Interactive comment on “A WRF simulation of the impact of 3-D radiative transfer on surface hydrology over the Rocky–Sierra Mountains” by K. N. Liou et al.

Received and published: 18 October 2013

Fig. 1

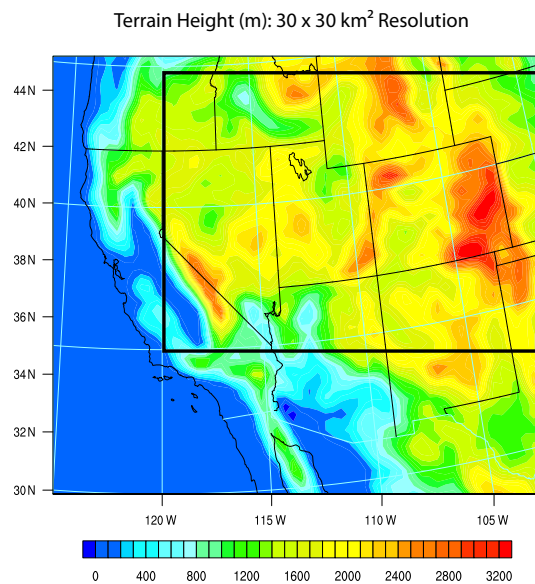
(2) The analysis box in Figure 1 should be marked darker and thicker. Figure 2d is of poor quality. The labels are not legible.

Response: Done. Also, the quality of Figure 2d (Fig. 2e in the revised version) has been improved. See also item (3) in the response to Reviewer 1.

Fig. 2

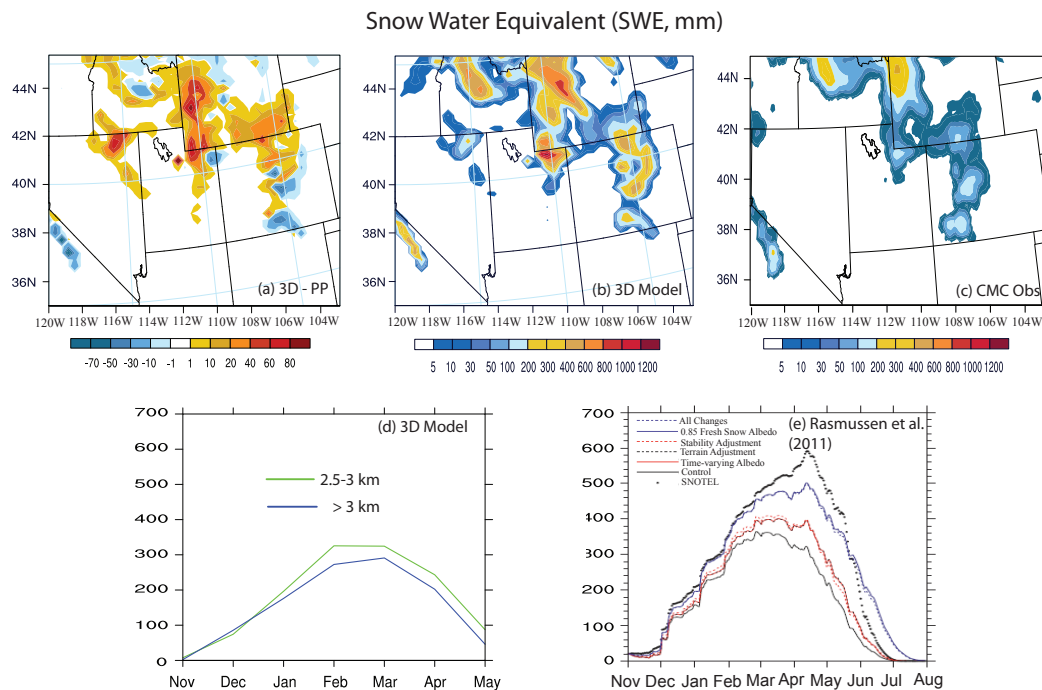
(4) It would be better to add the WRF-PP simulations of SWE together with WRF-3D in Figure 2. I am curious whether the WRF-3D simulates better SWE than WRF-PP.

Response: Following the Reviewer's comments, we have included contours of differences (3D – PP) in the simulated SWE (Fig. 2a). In comparison with CMC observations, WRF model results tend to produce larger SWE values over mountain areas. As shown, the incorporation of 3D radiation parameterization has reduced model over-estimation in reference to PP results to certain degree. However, the model over-estimation bias involving SWE can come from a number of sources, including snow

parameterization and precipitation bias, and cannot be solely resolved by 3D radiation parameterization.

Fig. 4

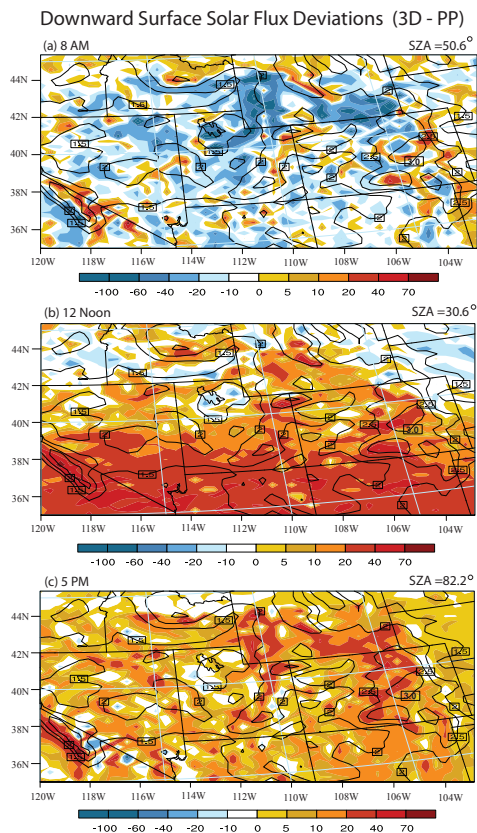
(1) Figure 4 shows the spatial distributions of the impact of topography on the surface solar radiation at three local times. The authors stated that the overall distributions of the topographical impact are locations relative to mountains. For example, “In the late afternoon, . . . , increases in solar flux are located on the southwest of the mountains, while decreases in solar fluxes are found in the northeast region.” This statement needs to be clarified. It implies that decreases in solar fluxes in the northeast region are due to the mountains to the south and west. In fact, surface solar radiation cannot be affected by mountains hundreds of kilometers away. Figure 4 does not provide any information on the relative location of a 30-km resolution grid box with respect to surrounding mountains. I suspect that the solar zenith angle should have an impact on the latitudinal distribution of the surface radiation. The small impact at higher latitude in panels (a) and (b) should at least be partially related to a larger SZA.

(7) Figure 4 labels are not clear. I was also wondering what is the size of the mountain relative to the 30km grid-boxes. It would be better to overlay a few contours of elevation height (1.5, 2, 2.5, 3 km) on the map.

Response: We thank the reviewer for the useful comments. To improve presentation of the mountain effect on surface radiation flux distributions, we have added terrain-height contours in Figure 4 for a 30 km resolution grid box and incorporated the following dis-

cussion: “Solar flux deviations at each grid box are affected by surrounding mountains through 3D radiation parameterization using a 1 km subgrid topographic data and the averaged solar zenith angle. For the north-south oriented mountains (e.g., the Sierras: 118-120W, 36-38N), positive/negative deviations are generally located at the mountain’s east/west sides in the morning (Fig. 4a) and its west/east sides in the afternoon (Fig. 4c). These deviations are distributed over the mountains and surrounding regions at noon (Fig. 4b). For west-east oriented mountains (e.g., 112-115W, 44N), positive deviations are primarily located at mountain south slope. Also, the solar zenith angle has an impact on the latitudinal distribution of solar flux deviations. Because less solar fluxes are available at high latitudes, solar flux deviations due to the 3-D mountain effect are smaller. However, positive/negative patterns are primarily dependent on mountain orientation and elevation.”

Response: Following this constructive suggestions, we have incorporated contours of elevation height in Figure 4. See also item (1) in our response to Reviewer 1.
